RE: **ABP REF:** ABP-300559-18
DCC REF: SHD0003/17
Location: Lands east of St. Paul's College, Sybil Hill Road, Dublin 5

Chief Executive's Report

**Response to An Bord Pleanála in accordance with the requirements of Section 8(5)(a)
of the Planning and Development (Housing) and Residential Tenancies Act 2016**

View A, Long range views are available westwards down the avenue. There is no visual intrusion from the surrounding suburbs.

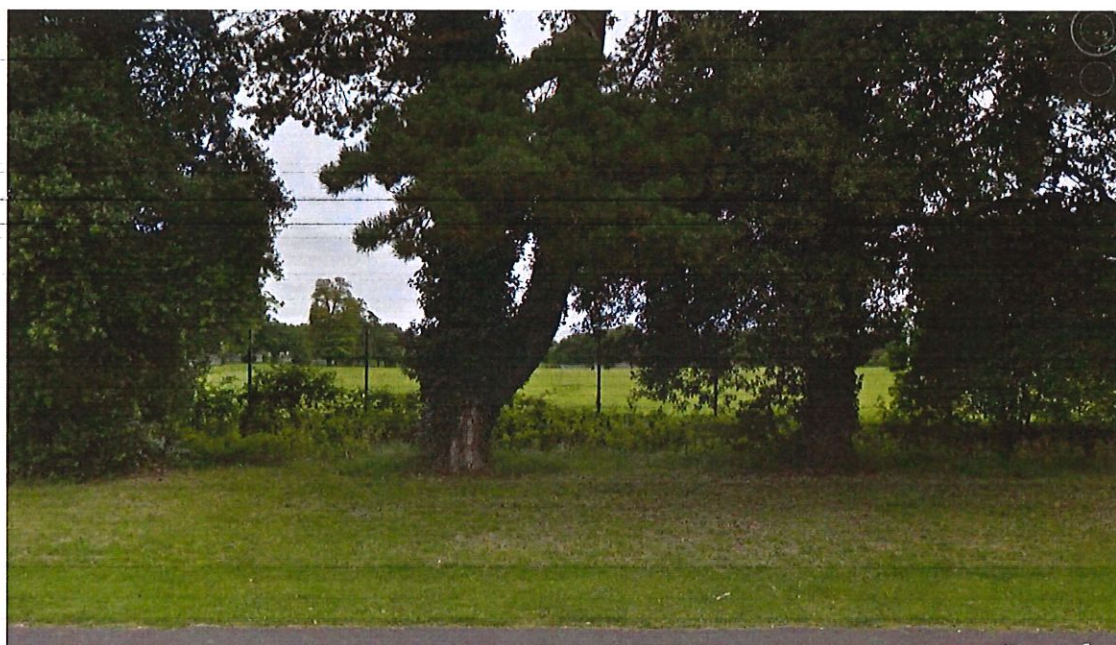
Views A, B & C from in front of the site of the former St Anne's mansion :

View B, Short range views are available to the north. There is no visual intrusion from the surrounding suburbs.

View C, Short range views are available to the south. There is no visual intrusion from the surrounding suburbs.

View D, Filtered view from avenue to St Paul's playing fields. There is no visual intrusion from the surrounding suburbs.

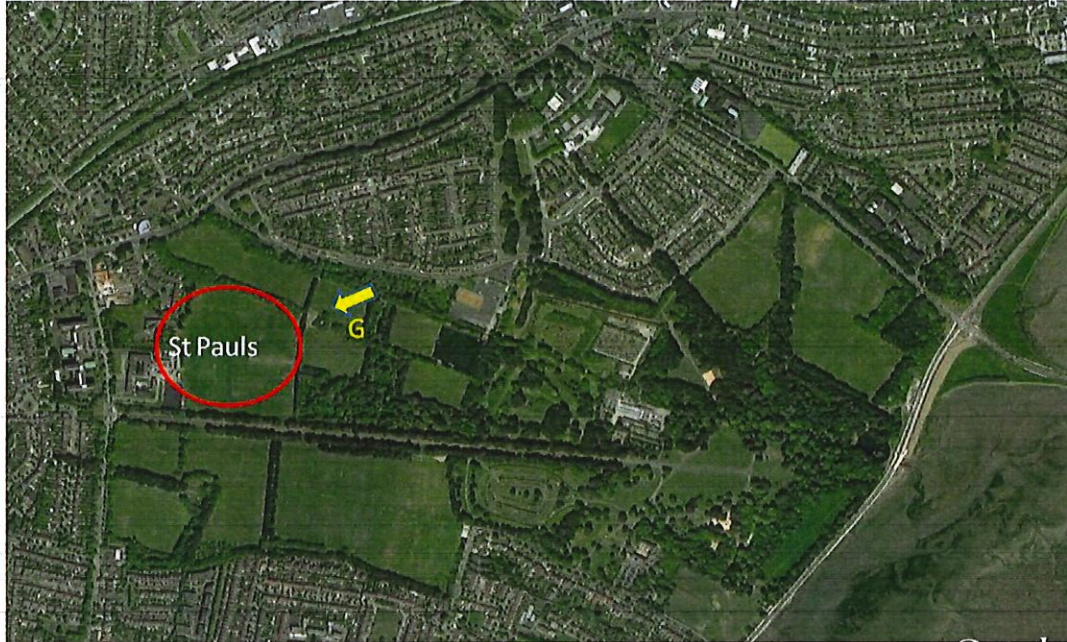
Views D, E & F from St Anne's Park avenue

View E, Long range directed view eastwards to the site of the former mansion. There is no visual intrusion from the surrounding suburbs.

View F, Open view southwards over playing pitches. There is no visual intrusion from the surrounding suburbs.
